# A G E N D A

## Architectural Review Board

April 27, 2021 – 5:30 p.m.

Attachment 5

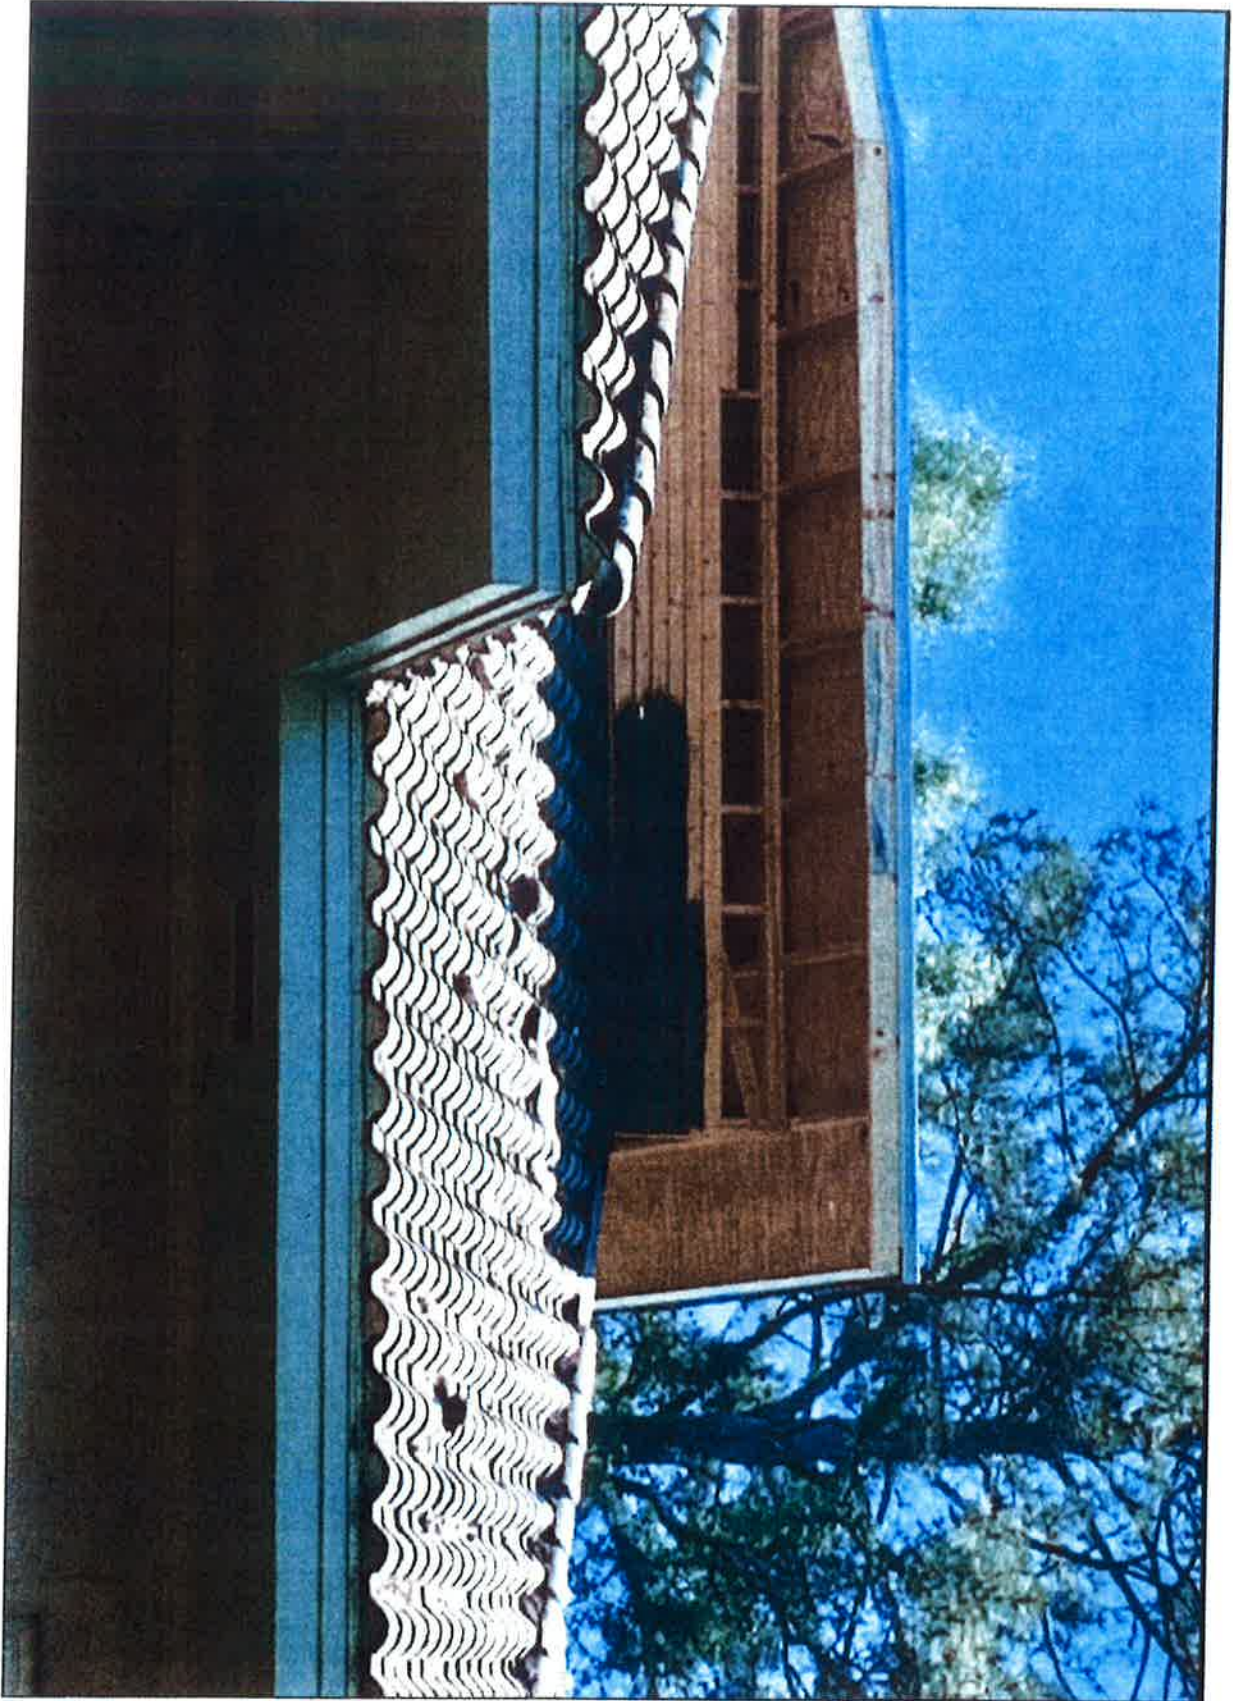
The petitioner is also requesting permission to install a fence along the shared property line with 1817 Lockerbie Street. A 6' wood privacy fence is proposed to a line parallel to the front corner of the house; a 4' metal (no variance required) is proposed to the property line at the street. The fences will be stained "Springfield Sage" (BM 510). At the March 23, 2021, meeting, the Board recommended that the section of privacy fence needed to be recessed from the front corner of the house, a site plan created by staff moving the fence to the rear corner of the porte cochere is also attached. The fence is ONLY proposed along the side property line, it will not have any return from the property line to the house across the driveway.

- The Board needs to consider whether it would have approved the roof structure had the petitioner requested permission first and if the modifications address the visual concerns expressed by the Board and adjacent property owners.
- The Board could consider an approval with conditions: that if this roof structure fails, prior to installing any other solution that may be taller than the existing roofline or encroach over the existing ridge lines requires an application be submitted for review.
- No objection to the fence.

PROPOSED FENCING FOR 553 & 559 CLOVERDALE RD  
 1/4" = 1'-0"  
 3.22.21

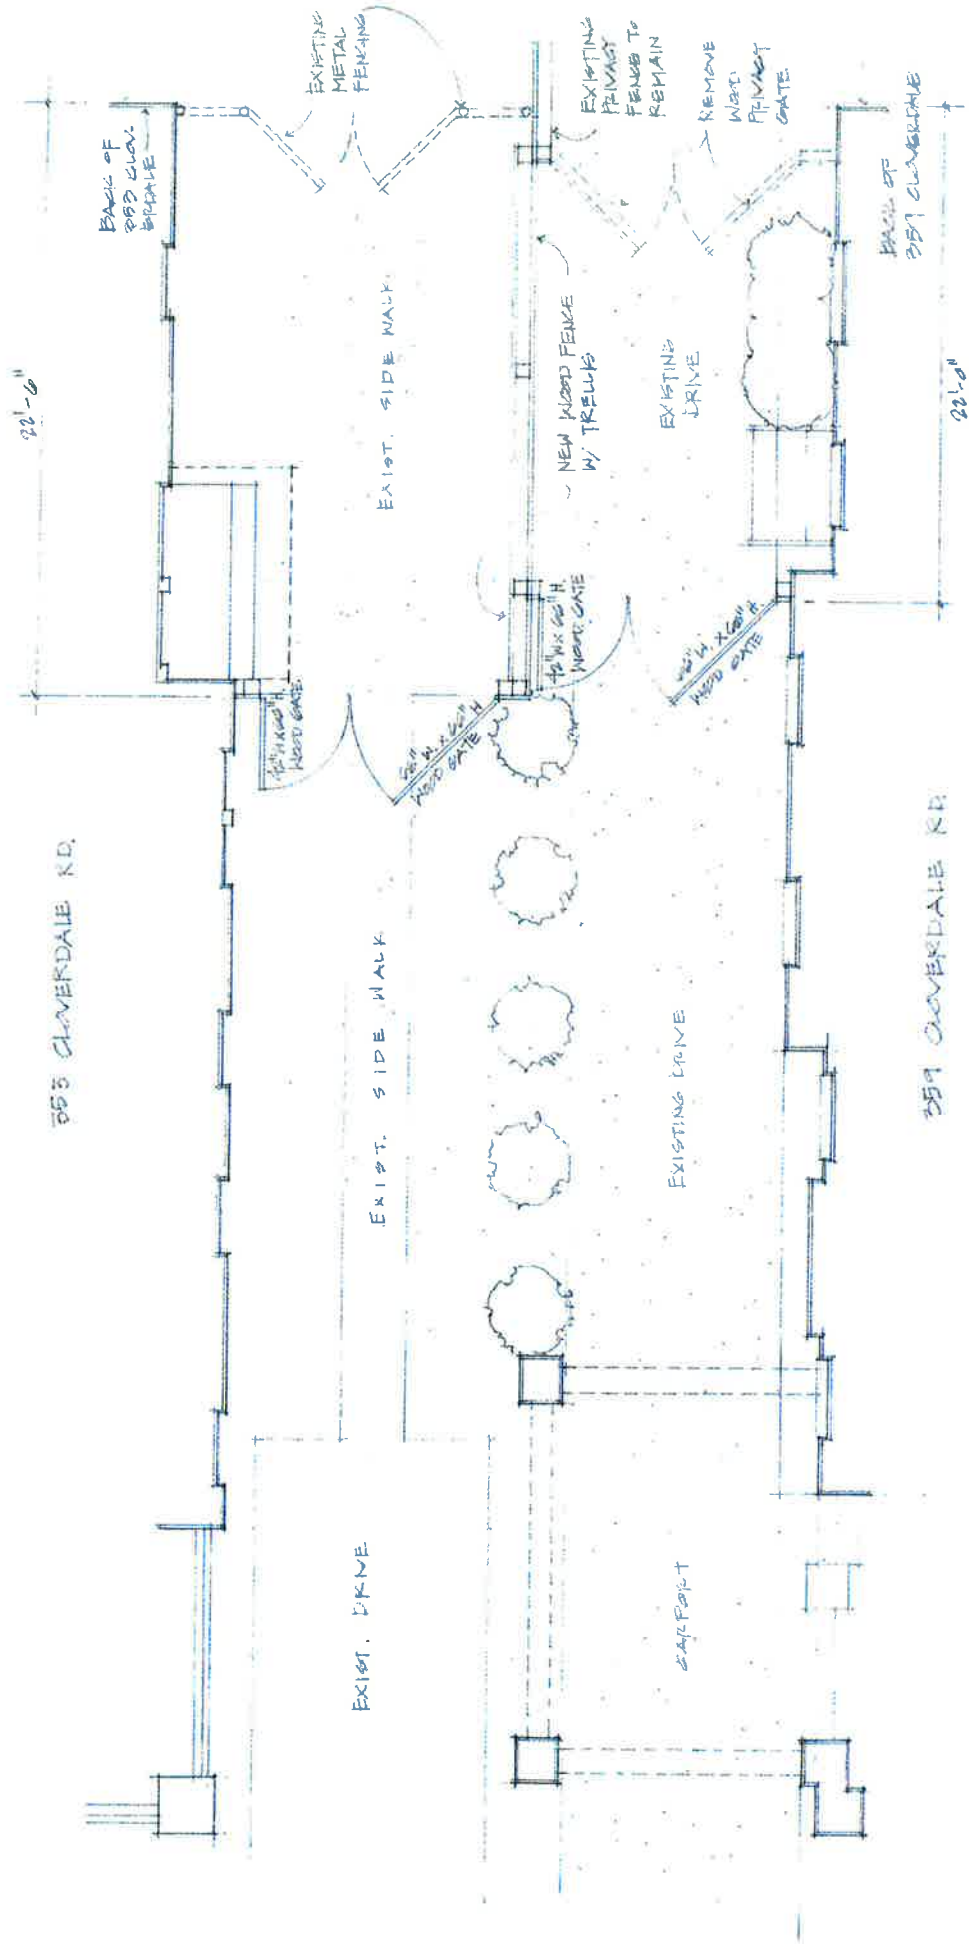
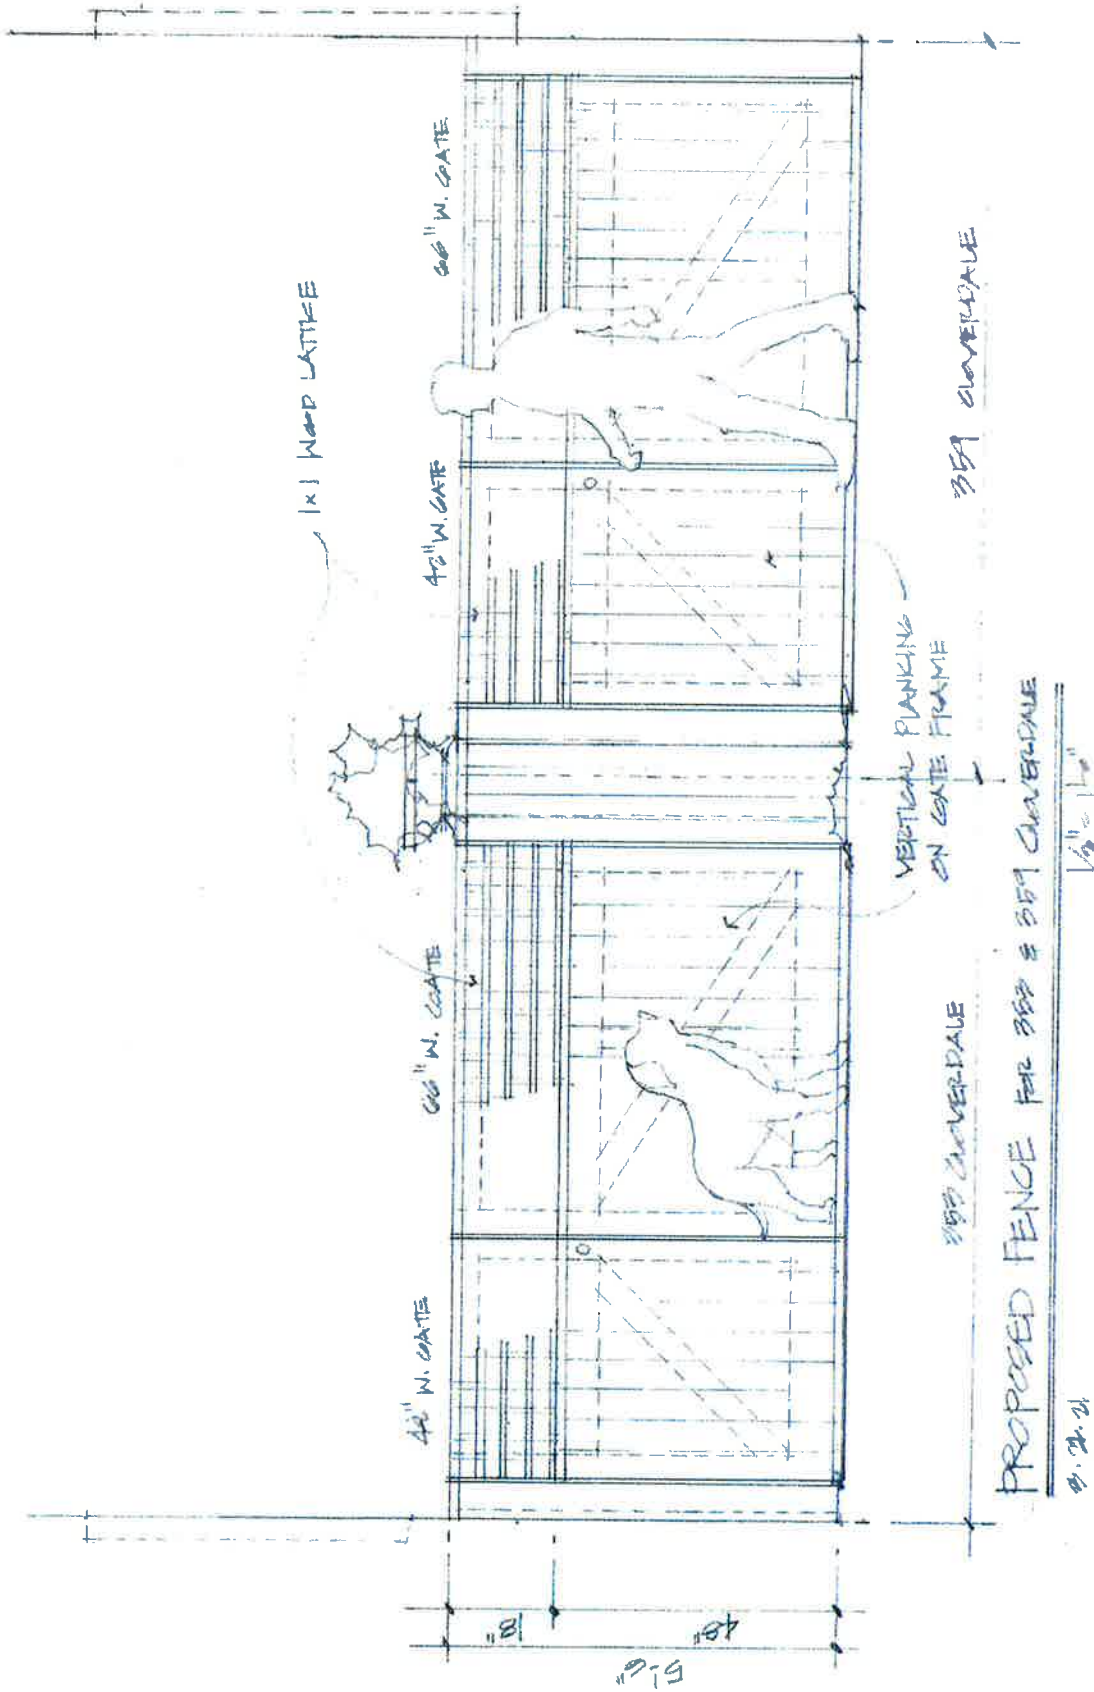
The proposal introduces a new fence along the property line of both properties and returns to each house to enclose the rear yards near the existing side/rear doors on the driveways. The proposed fence will be 48” of solid wood with 18” of lattice above to secure pets but have a lower profile than a standard privacy fence. The fence will be pressure treated pine with a clear sealer applied.

- This fence would have been approvable under the expedited procedures if it had been further to the rear of the properties. No objection.

6A

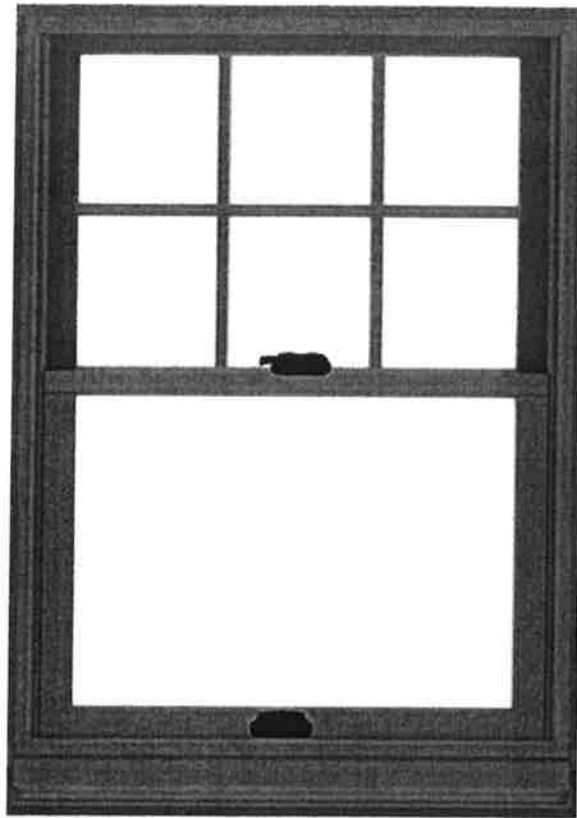
**REMARKS:** This request is being made to give the petitioner permission to replace 18 of the existing wood sash and casement windows with Andersen 400 Woodwrights (wood window with exterior vinyl cladding) with a simulated divided lite. Windows are to match the ones they replace: 6:6 sash with 6:6 sash; 6 lite casements with transoms proposed as 8 lite casements.

- Several years ago Southern Sash made a presentation to the Board to show different Weathershield windows with simulated divided lites: wood, aluminum clad, and vinyl clad. The Board declined to consider vinyl clad wood windows as vinyl is a non-historic, synthetic material.

- This house has long been neglected, 1998 file photos show boarded and replaced windows at the rear, Google street view from 2013 (the earliest available on Linden) shows the rear windows missing completely and/or boarded from the inside.
